5 In re: Docket Nos. 50-247-LR; 50-286-LR
6 License Renewal Application Submitted by ASLBP No. 07-858-03-LR-BD01
7 Entergy Nuclear Indian Point 2, LLC, DPR-26, DPR-64
8 Entergy Nuclear Indian Point 3, LLC, and
9 Entergy Nuclear Operations, Inc. September 9, 2015

11 PRE-FILED SUPPLEMENTAL REPLY WRITTEN TESTIMONY OF

12 Dr. RICHARD T. LAHEY, JR.

13 REGARDING CONTENTION NYS-25

Figure 1: Comparison of Limit Line (LL) and Best Estimate (BE) predictions, with embrittlement (BE_e) and without embrittlement (BE_{ne}).

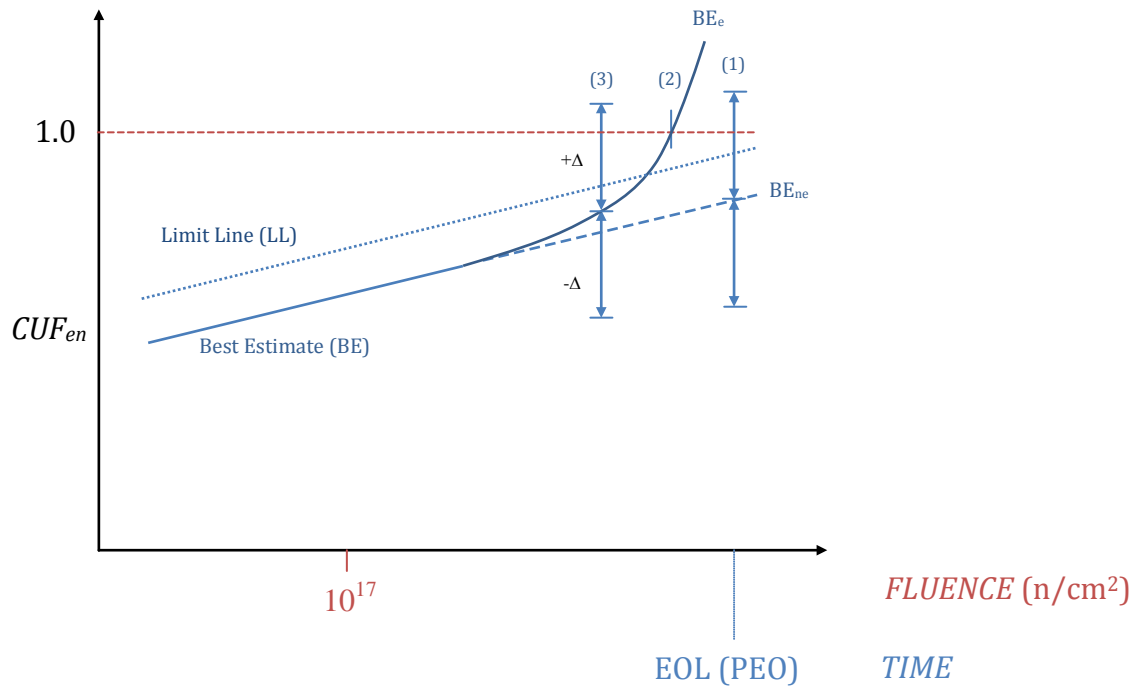
2 A. I prepared this Figure to visually illustrate some of
 3 the concerns that I have set forth in my testimony in this
 4 proceeding. Specifically, this Figure shows three important
 5 things: (1) a typical WESTEMS™ "Limit Line" prediction, (2) a
 6 "Best Estimate" prediction of CUF_{en}, the cumulative usage factor
 7 under reactor operating conditions, and the associated

1 uncertainty interval (Δ), and, (3) how the neutron fluence-
2 induced embrittlement of a RVI structure, component, or fitting
3 can dramatically increase the possibility of a fatigue failure,
4 as represented by the cumulative usage factor under PWR
5 operating conditions, CUF_{en} , being equal to unity. This figure
6 applies to RVI structures, components, and fittings made of
7 stainless steel or other materials. In summary, in Figure-1, I
8 have illustrated two different approaches for calculating a
9 time-dependent CUF_{en} , namely the "Limit Line" and the "Best
10 Estimate" calculation. For the "Best Estimate" line, I also
11 illustrate typical uncertainty intervals, delta (Δ), and the
12 effects of fatigue on embrittled (e) and on non-embrittled (ne)
13 RVIs.

17 [REDACTED]
18 [REDACTED] The "Limit Line" shown in Figure-1 includes
19 Entergy's implicit assumption that a stainless steel RVI
20 structure, component, or fitting remains perfectly ductile, and
21 thus shows that the CUF_{en} for a RVI will increase with an
22 increasing number of fatigue cycles, but that it is not affected
23 by the fluence. The "Limit Line", therefore, uniformly

1 increases in CUF_{en} even after the fluence exceeds 10^{17} n/cm²,
2 where significant embrittlement begins to develop (i.e., it is
3 assumed that the number of cycles to failure are not a function
4 of fluence). Figure-1 shows that, as the RVI component
5 approaches the end of life (EOL) for the period of extended
6 operation (PEO), [REDACTED] "Limit Line" will approach
7 (but still be below) $CUF_{en} = 1.0$. This is depicted as location
8 (1).

11 A. Not necessarily. As shown in Figure-1, a "Best
12 Estimate" prediction plus the uncertainty (Δ) may predict
13 possible RVI structure, components or fitting failures (i.e.,
14 $CUF_{en} = 1.0$), sooner than the "Limit Line" would. Moreover, the
15 effect of embrittlement can make the situation much worse. The
16 problem is that no one knows how much conservatism, if any, is
17 in the [REDACTED] "Limit Line". As a consequence, we can have no
18 confidence that "Limit Line" results near $CUF_{en} = 1.0$, are
19 sufficiently conservative to bound all the possible
20 uncertainties, as illustrated in Figure-1 by Δ .

20 A. Location (1) shows that, even if embrittlement is not
21 considered, RVI fatigue failure may occur by the end of life for
22 the period of extended operation. This is because the sum of a

1 "Best Estimate" prediction plus the uncertainty interval (Δ)
2 associated with this prediction would exceed $CUF_{en} = 1.0$. In this
3 case the "Limit Line" result is clearly non-conservative.

6 A. Location (2) shows that embrittlement can result in
7 the physical failure of the RVI well before the end of life for
8 the period of extended operation.

11 A. At location (3), the "Best Estimate" plus uncertainty
12 (Δ) for the case considering embrittlement (BE_e) predicts
13 possible failure of the hypothetical RVI component well before
14 the end of life for the period of extended operation, even
15 though the "Limit Line" prediction indicates substantial margin
16 to failure at this point. That is, at location (3) the CUF_{en} for
17 the "Best Estimate" line, accounting for embrittlement and for
18 all uncertainties (i.e., $BE_e + \Delta$), exceeds unity. Moreover, as I
19 have stated in my previous testimony, highly embrittled RVIs may
20 fail even sooner than by fatigue alone if significant seismic or
21 shock loads occur. That is, fatigue-weakened and embrittled
22 structures cannot tolerate large impulsive seismic and shock
23 loads like fully ductile structures can. Moreover, other

1 synergistic aging effects, such as the thermal embrittlement (TE)
2 of some CASS RVIs (the upper part of the core support columns)
3 would may move the BE_e curve to the left of its position shown in
4 Figure-1 (i.e., the RVI would be predicted to reach failure,
5 $CUF_{en} = 1.0$, even sooner than the cases (2) and (3) in Figure-1).

8 A. Yes. Because of Entergy's failure to explicitly
9 account for uncertainties, and for the effect of embrittlement
10 on fatigued RVIs, we can have no confidence in the "Limit Line"
11 type of CUF_{en} predictions [REDACTED]
